**CITY OF SNELLVILLE
DEPARTMENT OF PLANNING & DEVELOPMENT
MAYOR AND COUNCIL**

CASE NUMBER: RZ 20-01 CUP 20-01

REQUEST: Rezoning, Conditional Use Permit, Request for Variances

DEVELOPMENT/PROJECT: Floral Shop & Auto Service and Repair Shop

The proposed site plan, submitted by the applicant.

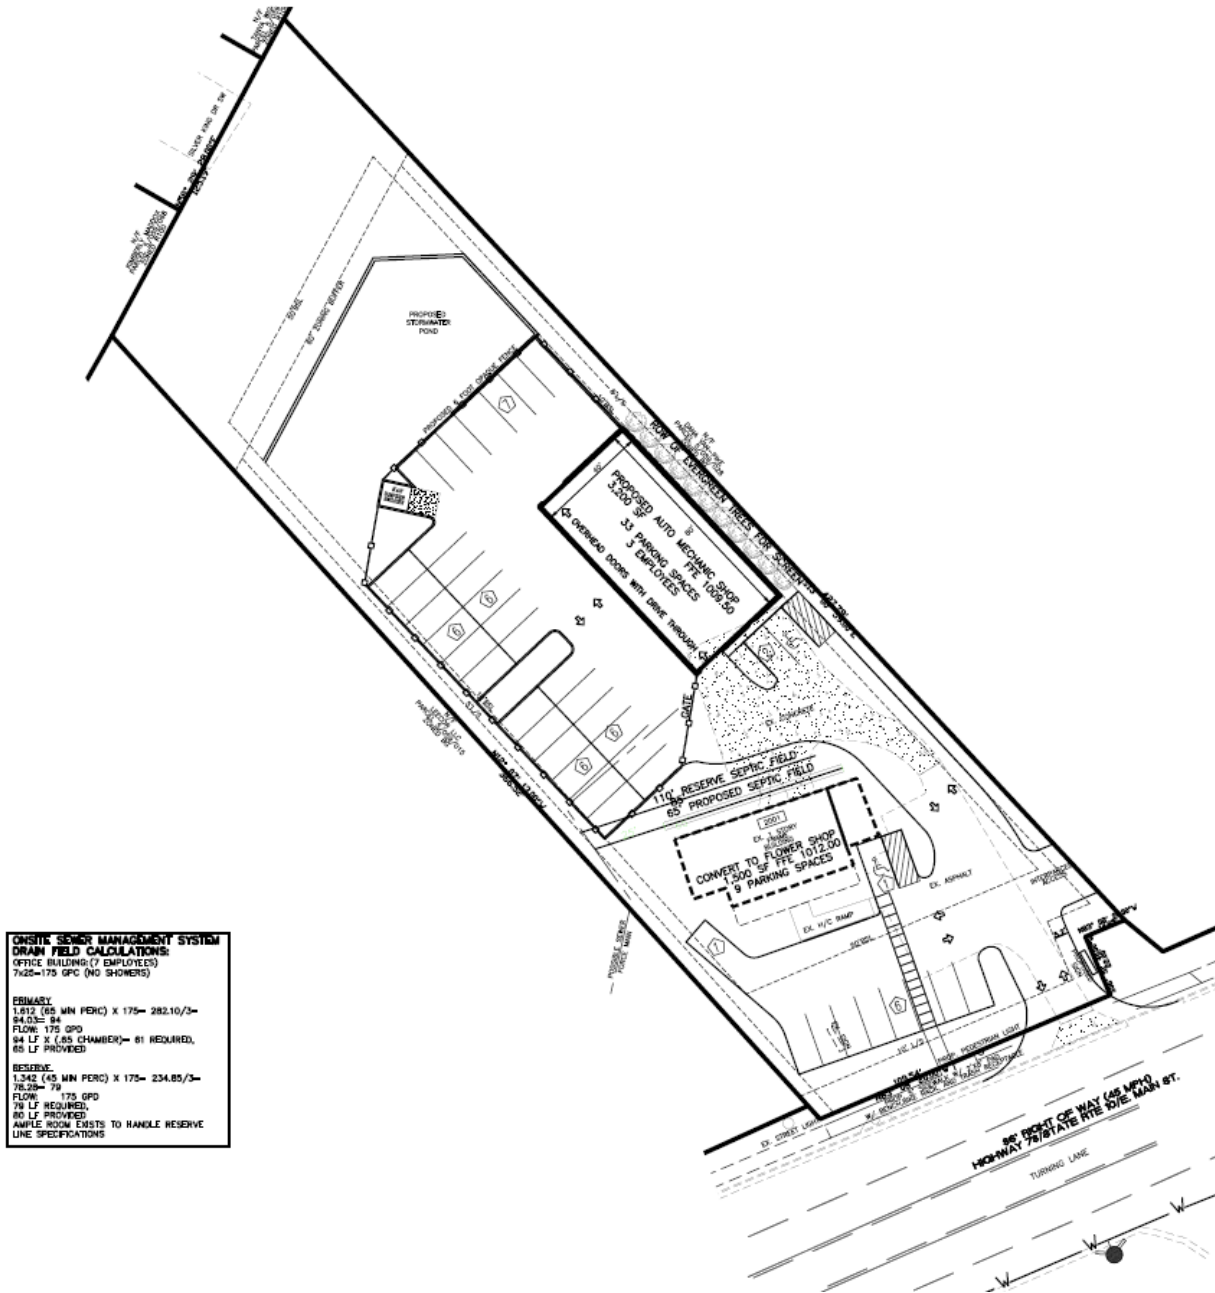
The existing structure is located in the southern portion of the property, and is setback approximately seventy-eight (78) feet from the US-78 / E. Main Street right-of-way. Improvements to the existing parking area include seven (7) parking spaces and one (1) handicap parking space located in front of the existing building.

The rezoning site plan shows a proposed five (5) foot wide sidewalk with small amenity pad for a pedestrian bench, trash receptacle and bicycle rack. One pedestrian light is shown adjacent to the amenity pad. Pedestrian connectivity between the sidewalk and entrance to the existing building is provided by a five (5) foot wide hatched walkway in the parking lot with a concrete walkway connection from the parking lot curb to the sidewalk. Although the applicant is proposing construction of a five (5) foot wide sidewalk along the right-of-way, in 2010 the adjacent property to the west (Future Services) was required to install a six (6) foot wide sidewalk per the City Code, so continuation of the six (6) foot wide sidewalk for this project will also be required (see Condition #7).

Although no monument sign drawings have been provided by the applicant, there is a proposed sign shown just east of the full-access drive. The final sign location may vary in order to comply with the sign ordinance requirements for sign type, sign area, sign height, and sign setback from the right-of-way.

An inter-parcel access stub is shown just to the east of the full-access drive that could provide future connectivity to the adjacent Family Tree Nursery property should they choose to make the final connection.

There is a two-way driveway that provides vehicle access to a 3,200 sq. ft. proposed auto mechanic shop and related parking. Two (2) parking spaces are shown in front of the proposed building with the majority of the parking to the side and rear of the proposed building. There are seven (7) spaces in the rear of the building and twenty-four (24) spaces along the side

The site plan shows sixty-five (65) feet of proposed septic system drain field with an additional one-hundred-ten (110) feet of reserve strip for future septic use. The nearest sanitary sewer manhole is located to the west approximately four-hundred-twenty-five (425) feet from the property line, well outside the threshold requiring connection to sanitary sewer.

One dumpster pad and enclosure is shown in the northwest corner of the mechanic shop parking lot. Although there is no dumpster pad and enclosure shown for the existing building, one shall be required to serve the future flower shop or other tenant use (see Condition #2). The code requires these enclosures to be eight (8) feet in height and made of brick, stucco, or split-face block.

Although no detail has been provided nor shown on the colored rendering, there is a proposed six (6) foot high opaque fence with gate will enclose the main parking area of the auto mechanic shop for security and screening of vehicles that are parked or stored outside.

There is a proposed stormwater detention pond located behind the auto mechanic parking area which includes a concrete retaining wall.

There is a sixty (60) foot undisturbed buffer shown that separates the proposed commercial use from the two residential lots of the Saddle Club Estates subdivision. Combined with the stormwater detention pond location, the proposed auto mechanic shop is approximately one-hundred-sixty-two (162) feet from the rear property line and the Saddle Club Estates subdivision.

1. The property shall be developed according to the site plan entitled “Rezoning Plan & CUP Plan for 2001 Main St. East”, dated 11-30-2019 and stamped received 1-14-2020, with modifications permitted due to engineering restraints, ingress and egress, and/or to meet conditions of zoning or State, County, and City regulations.

2. Applicant shall provide a separate dumpster pad and enclosure constructed in accordance with Sec. 19-34 of the City Code for use by the existing building tenant and shall be located in close proximity to the existing building.

7. New sidewalks shall be a minimum of six (6) feet in width.
